HL137N-Series

Space-saver' trap, optionally with washing device connection or air admittance valve

The redesigned HL137N space-saving trap replaces the previous HL137 model and is characterised by a number of improvements. Flexibility and optimal adaptability to different installation situations have been kept from the previous model. At the same time, the series has been expanded to include a version with an integrated air admittance valve and a version with a washing device connection.

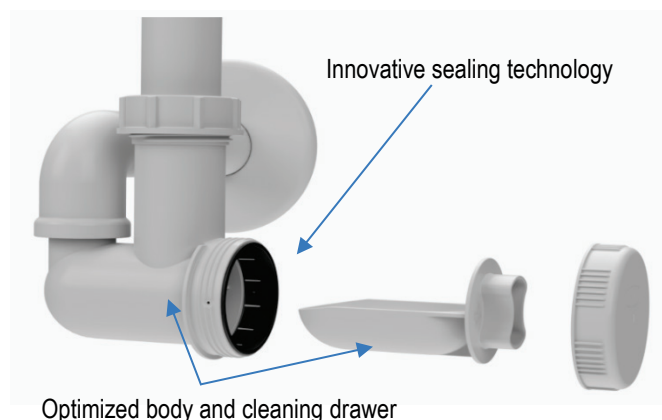
Modifications of the new HL137N:

Cleaning drawer

The cleaning drawer has been re-designed so that it can be opened and removed smoothly with one hand. This means that blockages in the trap can be cleared easily and without tools.

Efficient installation and sustainability

The bent outlet was shortened, which eliminates the on-site trimming. This simplifies the installation, saves time, and reduces material waste.

Optimized positioning

The cleaning drawer of the new HL137N is positioned so that it can be removed without tools, even when the angle valves are too close together. This makes cleaning easier, even in inconvenient installation conditions.
